Project	IEEE 802.16 Broadband Wireless Access Working Group < http://ieee802.org/16 >	
Title	Extension of collaborative spatial multiplexing in OFDMA	
Date Submitted	2004-08-29	
Source(s)	Bin-Chul Ihm, Yongseok Jin, Jinyoung Chun, Kyuhuk Chung LG Electronics, Inc. 533, Hoge-1dong, Dongan-gu, Anyang-shi, Kyongki-do, Korea	Voice: 82-31-450-7187 Fax: 82-31-450-7912 [mailto: {bcihm, jayjay, jychun03, kyuhuk} @lge.com]
	Dong-Cheol Lee, Chi-Man Lee, Ki-Jun Lee, Dacom 706-1, Yeoksam-Dong, Gangnam-Gu, Seoul, 135- 987, Korea	Voice: 82-505-889-4248 Fax: 82-505-889-0315 [mailto: dclee@dacom.net, lcm2000@chol.com, mobile95@dacom.net]
	Koo-Hyun Um, Inkyu Paek, Pyung-Su Park Hanaro telecom 470-9, Shindaebang-dong, Dongjak-gu, Seoul, Korea	Voice: 82-2-6266-5266 Fax: 82-2-6266-5309 [mailto: pspark@hnao.com]
Re:	This is a response to a Call for Comments on IEEE P802.16e-D4	
Abstract	The collaborative spatial multiplexing can be applied to the case in OFDMA Blue line indicates new text change part. Green line indicates harmonized part.

Extension of Collaborative Spatial Multiplexing in OFDMA

Figure -252b Uplink pilot allocation for 4-antenna SS for AMC zones

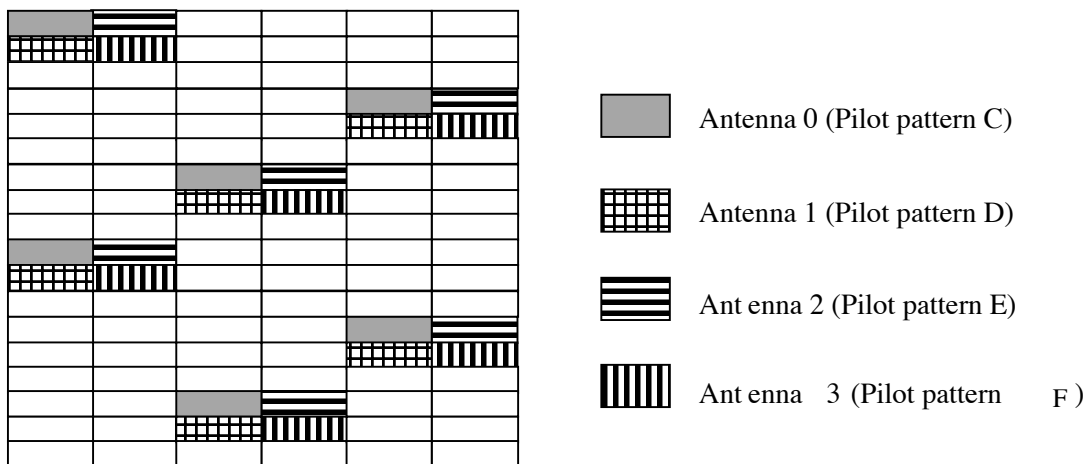
For 4-antenna SS and the AMC, pilots for each antenna shall be allocated as shown in Figure 252b

Two dual transmit antenna MSSs can perform collaborative spatial multiplexing onto the same subcarrier. In this case, one MSS should use uplink pilot allocation with pattern-C and pattern-D, and the other MSS should use the uplink pilot allocation with pattern-E and pattern-F.

Figure yyy – MIMO tile in UL PUSC mode

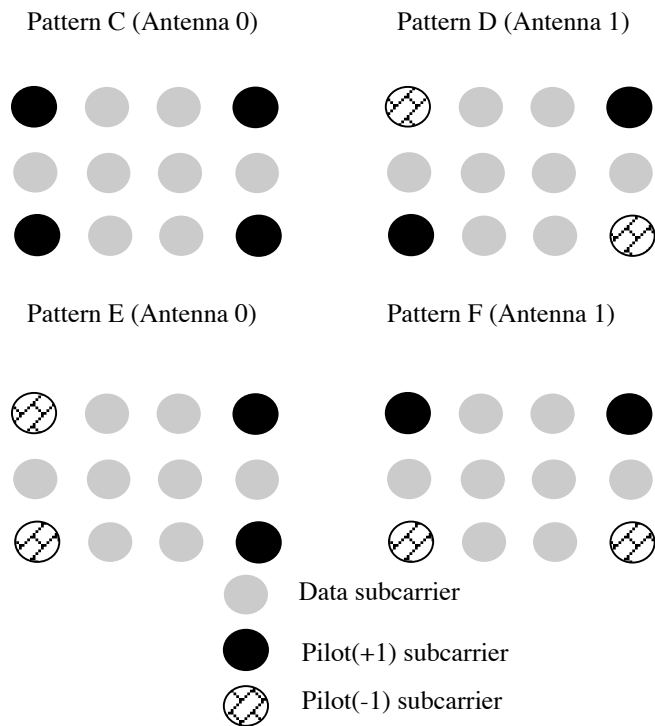
A user supporting transmission using STC configuration in the uplink, shall use a modified uplink tile, 2-transmit diversity data or 2-transmit spatial multiplexing data can be mapped onto each subcarrier, the mandatory tile shall be modified to accommodate those configurations. Figure yyy depicts the UL tiles for enhanced STC transmission in PUSC mode.

Two SS's of one or two transmission antenna can perform collaborative spatial multiplexing onto the same subcarrier. In this case, each SS should use the uplink tile with the pilot pattern indicated in MIMO_UL_Enhanced_IE. A dual transmit antenna SS can use the allocation in STTD, SM or collaborative SM mode with other SS. SS in collaborative SM mode with dual transmit antenna sends data in ordinary STC configurations as in section 8.4.8.1.4 using the pilot pattern pair indicated in MIMO_UL_Enhanced_IE. The first pilot pattern in each pair is for antenna 0 and the second is for antenna 1.
